SEWAGE DISPOSAL SYSTEM

DEPARTMENT OF HEALTH AND MENTAL HYGIENE

A REPAIR

SUBDIVISION _____ LOT _____ ROAD 16400 Fredrick Road

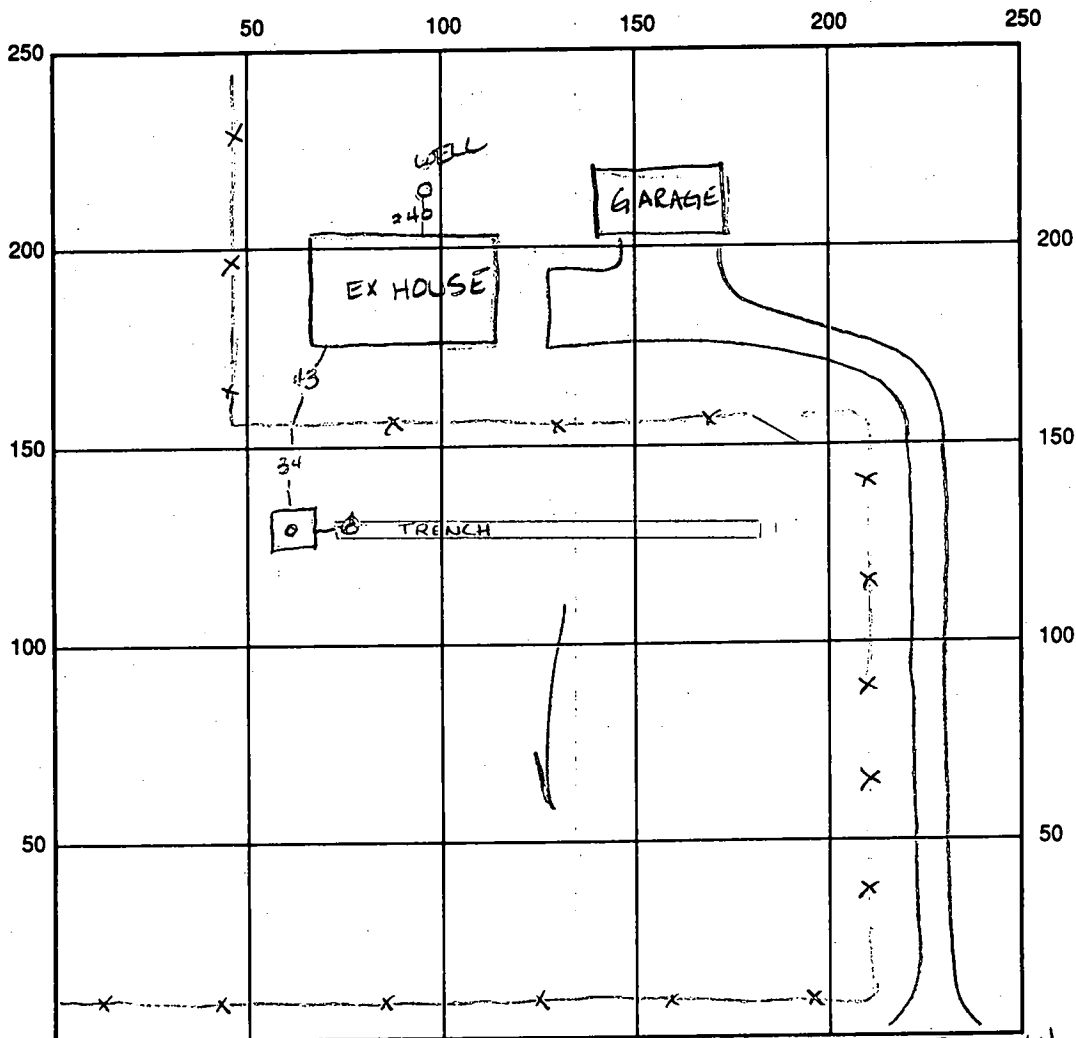
5/3/96
Inlet 4.0, bottom at 9.0 Run trench on contour toward
the right property line when facing lot from Rt. 144 due

REMARKS: 5/3/96 Test hole dug - see above Auw 5/4/96 OK to cover
all work final Auw

* No tag on well Auw
